HUDDERSFIELD

DESIGN & ACCESS STATEMENT ADDENDUM

SEPTEMBER 2024

Fig. 6.1.2 Proposed Amended Plan - Basement Floor Plan

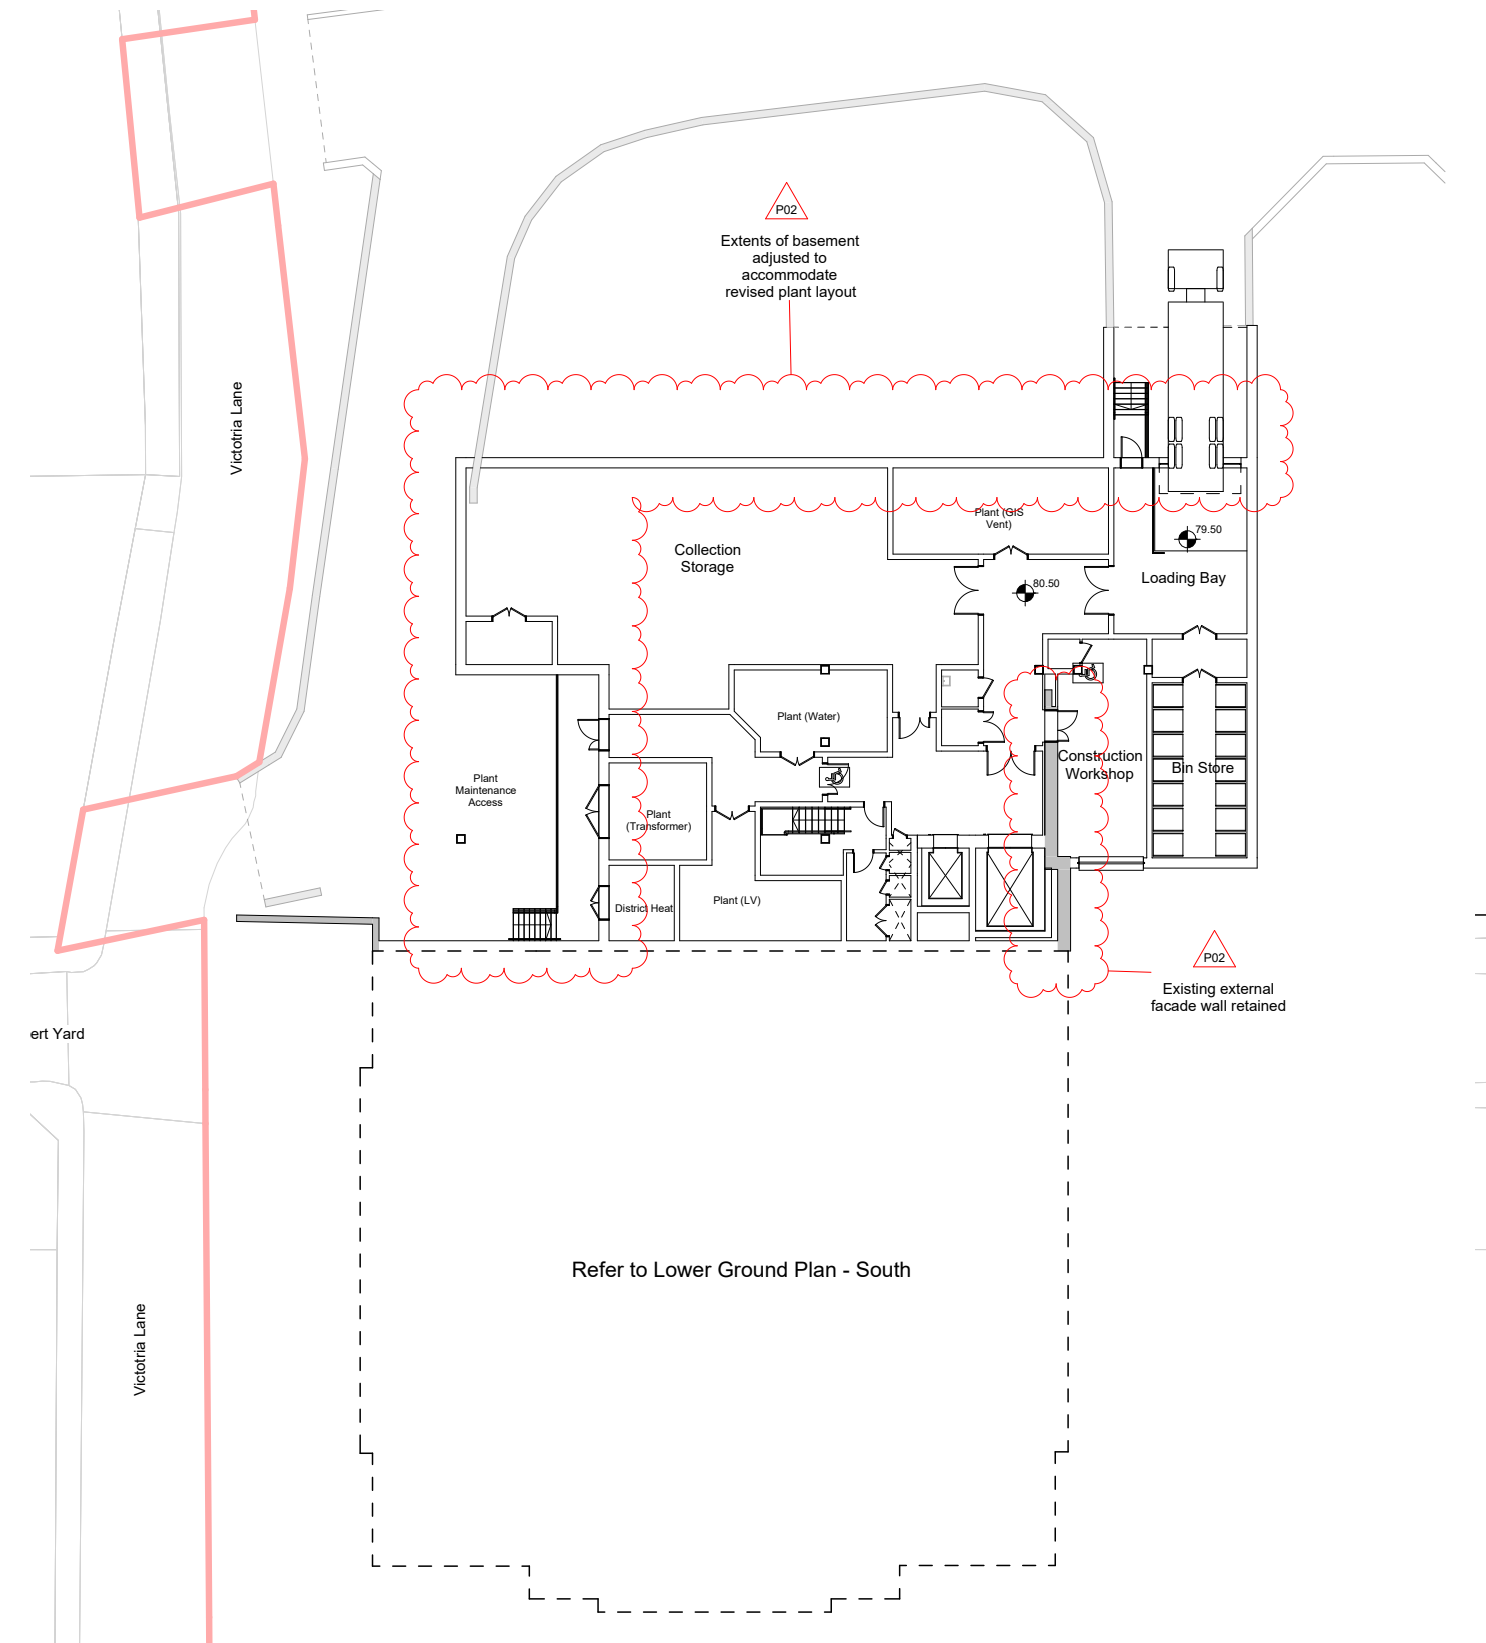
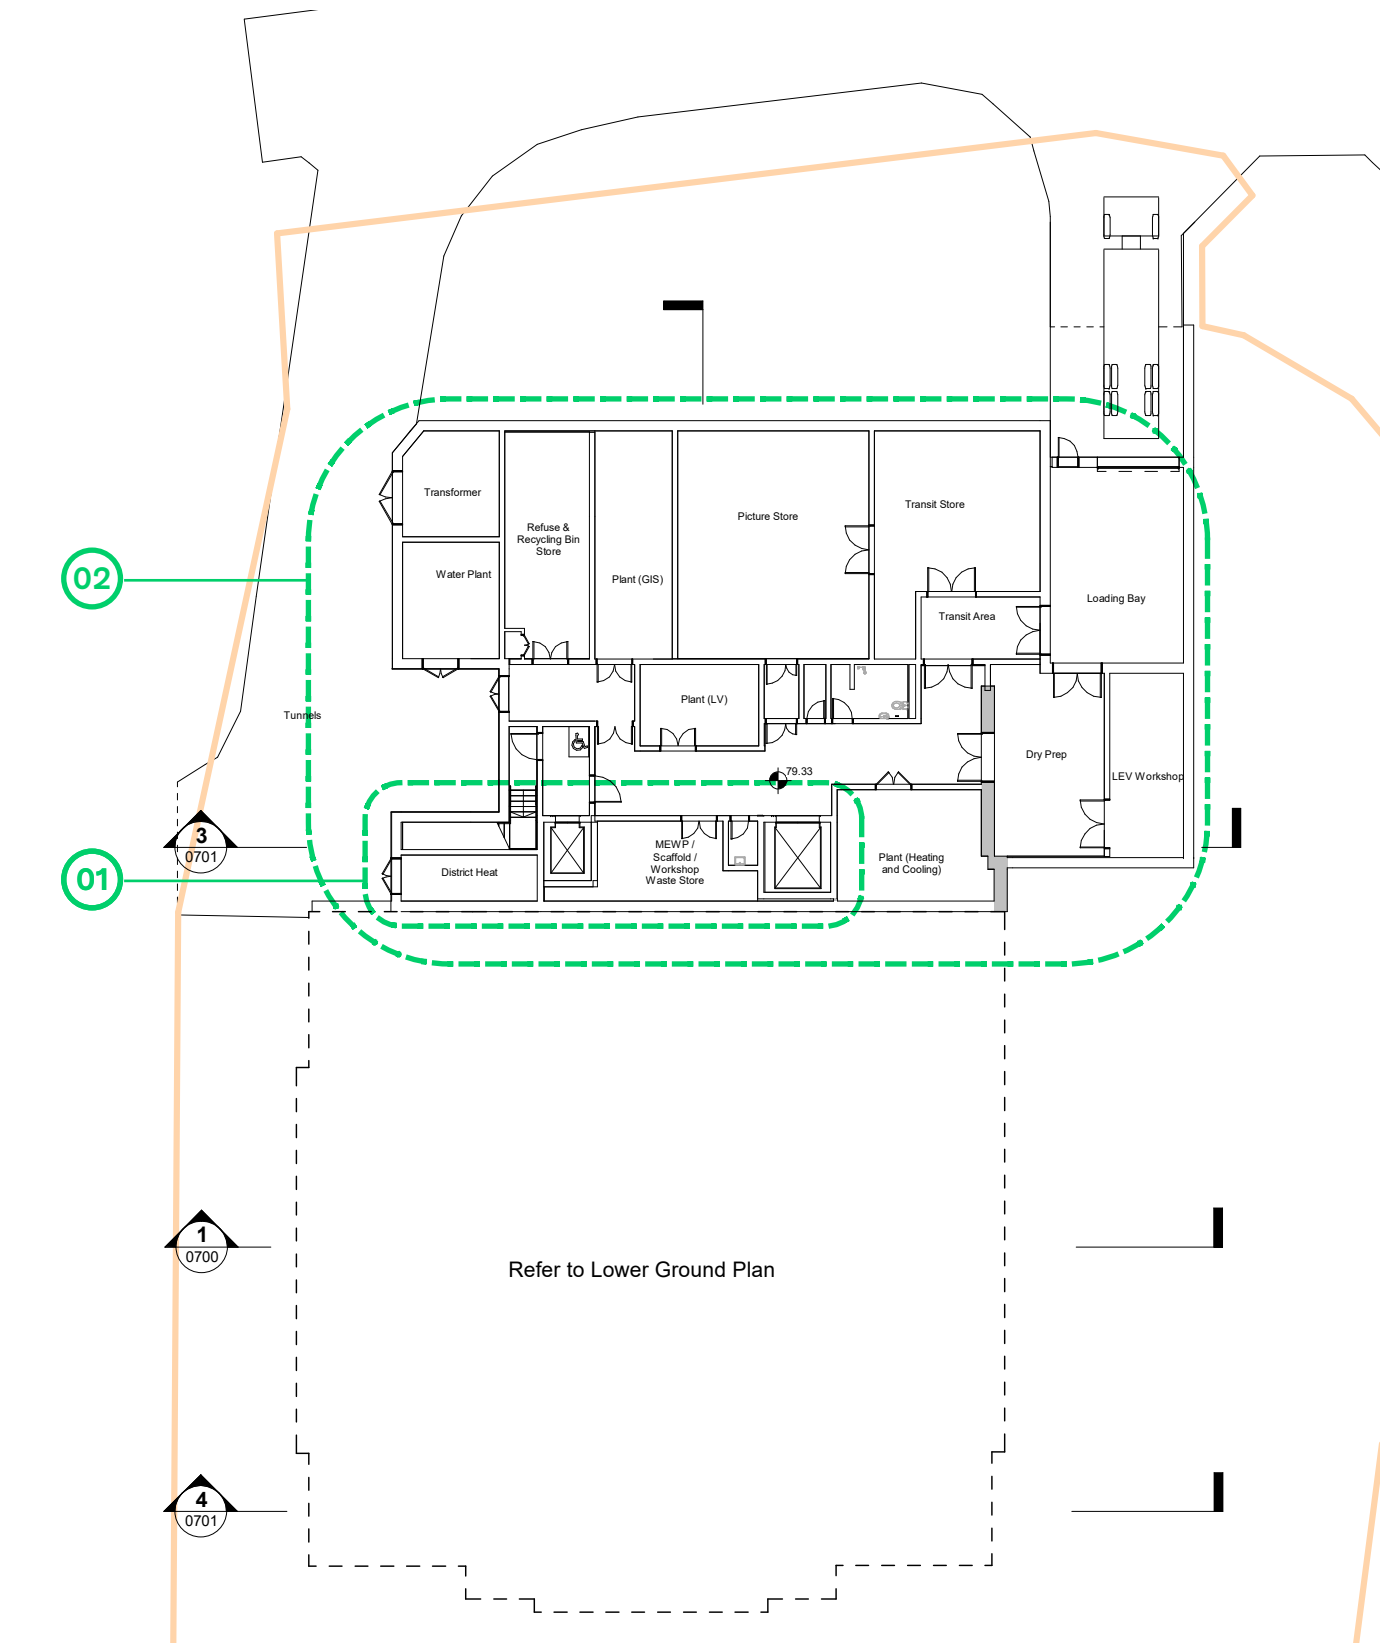
- 01 Rationalisation and relocation of stair core and lifts.
- 02 Basement north and south retaining walls moved 1.7m north. Layout updated to suit changes in brief and vertical circulation.

Fig. 6.1.4 Proposed Amended Plan - Lower Ground Floor Plan

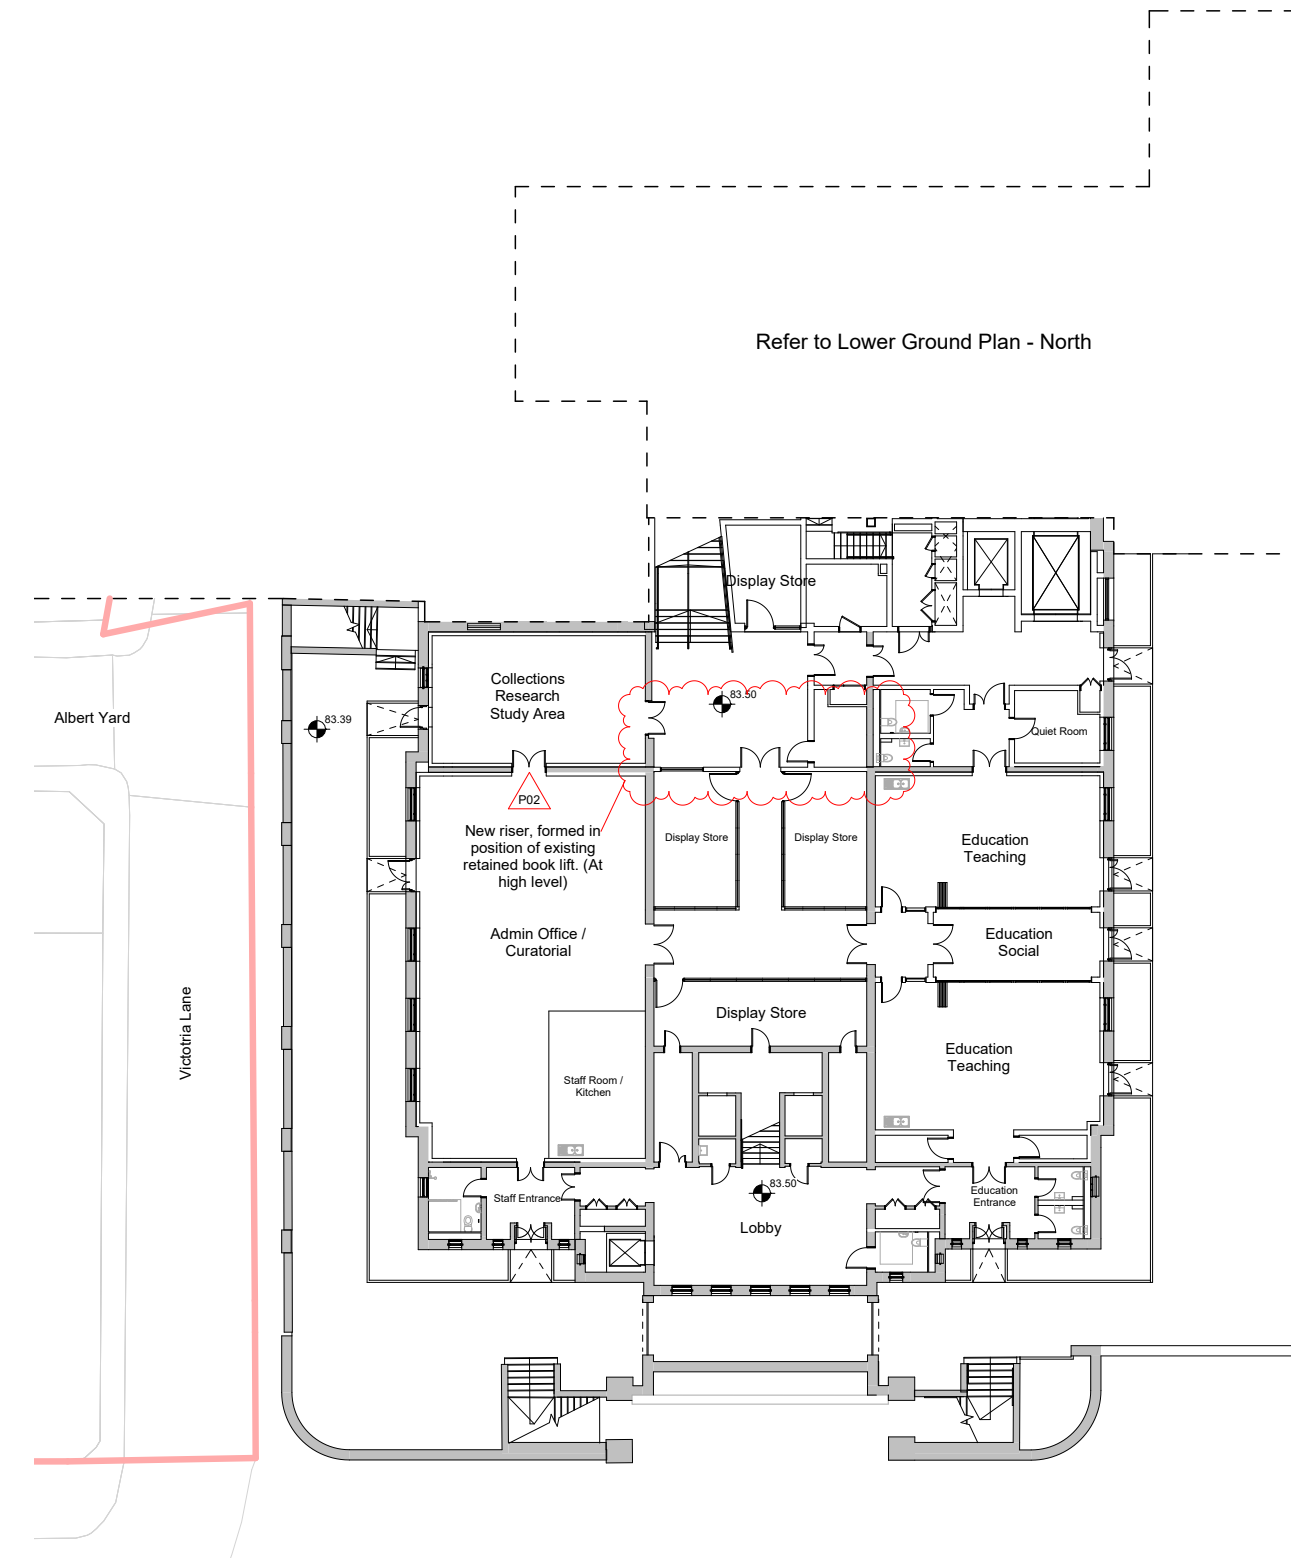
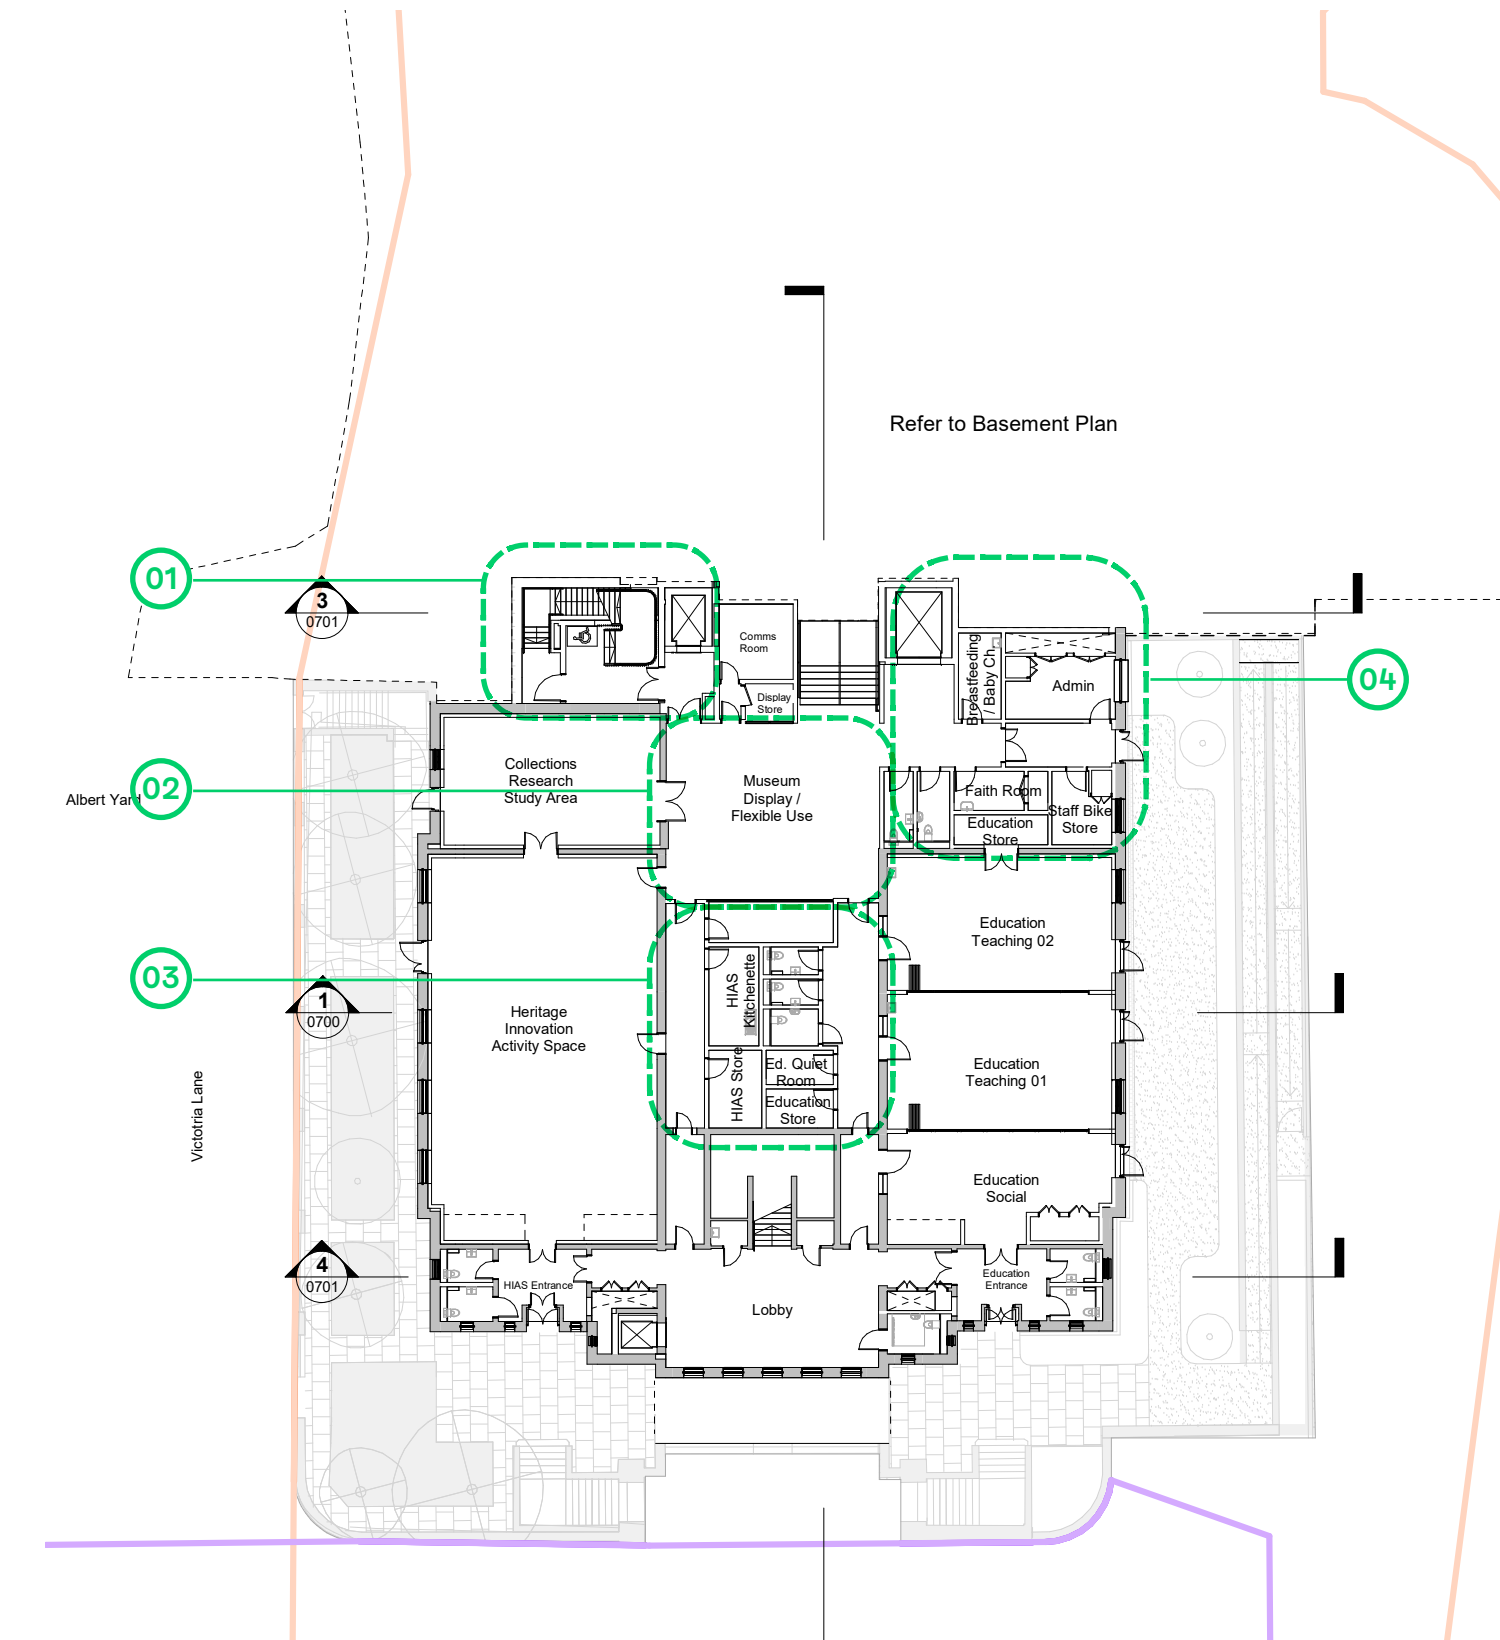
- 01 Rationalisation and relocation of stair core and lifts.
- 02 Access to Lower Ground Floor from new northern extension reconfigured to provide better connectivity and visibility alongside addition are for museum display space.
- 03 Central zone reconfigured to allow for circulation routes and back of house provision for Education and HIAS spaces.
- 04 North-Eastern zone reconfigured following refinement and relocation of stair and lifts.
